**PROFESSIONAL ON-SITE WASTEWATER RE-USE ASSOCIATION OF NEW
MEXICO, INC.
P.O. Box 8542
Santa Fe, NM 87504
(505)988-7676**

May 4, 2010

Re: Amended Petition for Public Hearing to Consider Proposed Amendments to the Liquid Waste Disposal and Treatment Regulations in Title 20, Chapter 7, Part 3 of the New Mexico Administrative Code except for Section 20.7.3.904 NMAC which was the subject of a separate hearing already held.

Table 901.1. Nitrate as Nitrogen (NO₃-N) Calibration Data (mg/L).

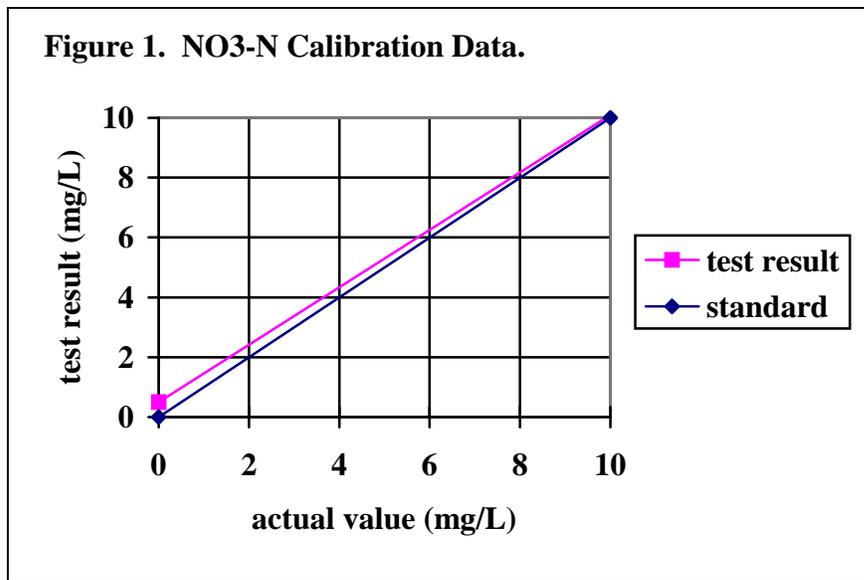
C. Amend to add the following after the words "requirements of the permit": "Field instruments may be used as an alternative to laboratory analyses for TN constituents in accordance with the following protocol.

1. Field instruments shall be operated in accordance with the manufacturer's instruction manual.
2. Factory prepared standards and blanks of de-ionized water shall be used to draw calibration curves with a minimum of two points (see example in Table 1 and Figure 1). At least one calibration curve shall be prepared for each lot number of chemical reagents used.
